THIRD ERRATA SHEET FOR AGENDA ITEM #1

To: Planning Commission
From: Scott Donnell, Senior Planner
Via Don Neu, City Planner
Re: **Third Errata Sheet for Agenda Item #1 – GPA 16-01/ZCA 16-01/ZC 16-01/MP 14-01/LCPA 14-01/MCA 16-01 (DEV08014) – VILLAGE AND BARRIO MASTER PLAN**

Figure 2-2, Use Restrictions Map

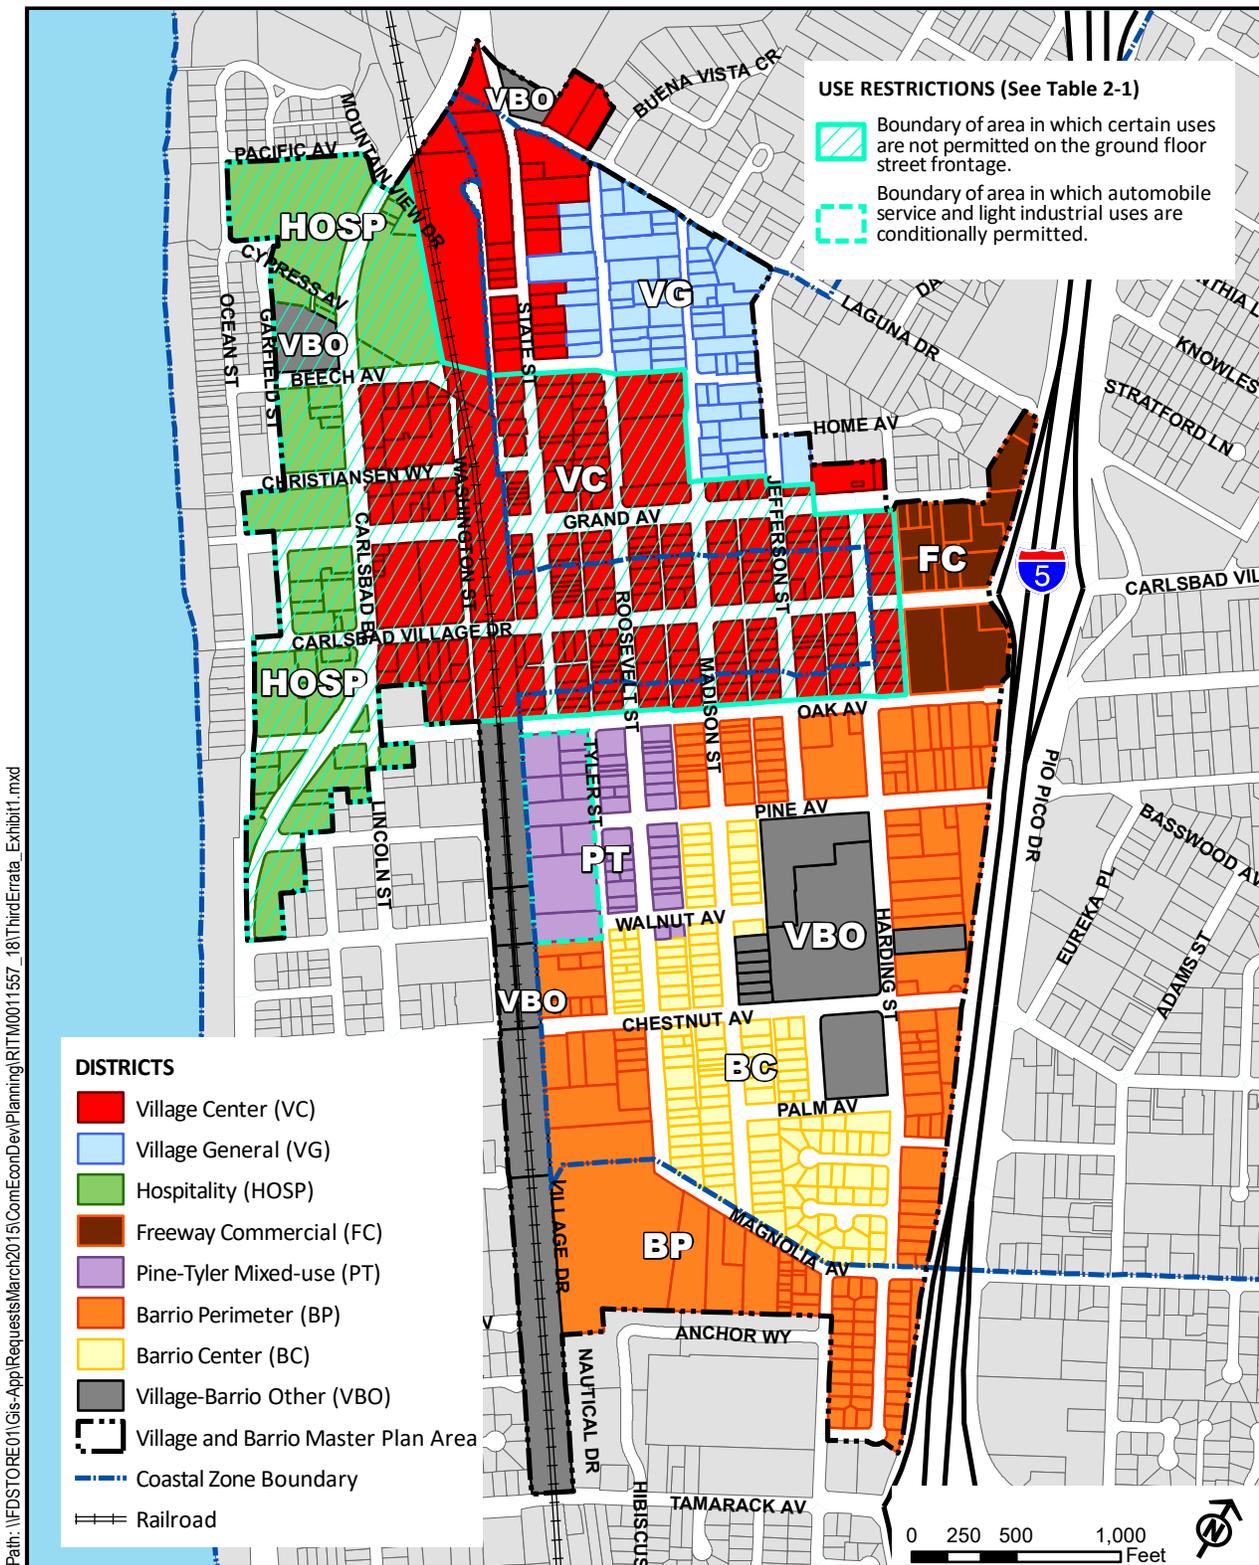
<p>2-40</p>	<p>Section 2.7.1, Village Center Supplemental District Standards</p>	<p>1. Add new Section 2.7.1 I., Ground Floor Uses, as follows:</p> <p><u>I. GROUND FLOOR STREET FRONTAGE USES</u></p> <p><u>1. New ground floor street frontage uses permitted within the boundaries of the use restriction area identified on Figure 2-2 shall occupy more than one-half of the habitable space developed on the ground floor and shall span at least 80 percent of the building frontage.</u></p> <p><u>2. Up to 20 percent of a building frontage may be used for a lobby or entryway to uses above or behind ground floor street frontage uses.</u></p> <p>2. Renumber existing Section 2.7.1 I., Good Neighbor, to 2.7.1 J.; and existing Section 2.7.1 J., Railroad Corridor, to 2.7.1 K.</p>
<p>2-52</p>	<p>Section 2.7.3, Hospitality District Supplemental District Standards</p>	<p>1. Add new Section 2.7.3 I., Ground Floor Uses, as follows:</p> <p><u>I. GROUND FLOOR STREET FRONTAGE USES</u></p> <p><u>1. New ground floor street frontage uses permitted within the boundaries of the use restriction area identified on Figure 2-2 shall occupy more than one-half of the habitable space developed on the ground floor and shall span at least 80 percent of the building frontage.</u></p> <p><u>2. Up to 20 percent of a building frontage may be used for a lobby or entryway to uses above or behind ground floor street frontage uses.</u></p> <p>2. Renumber existing Section 2.7.3 I., Master Site Plan, to 2.7.3 J.</p>
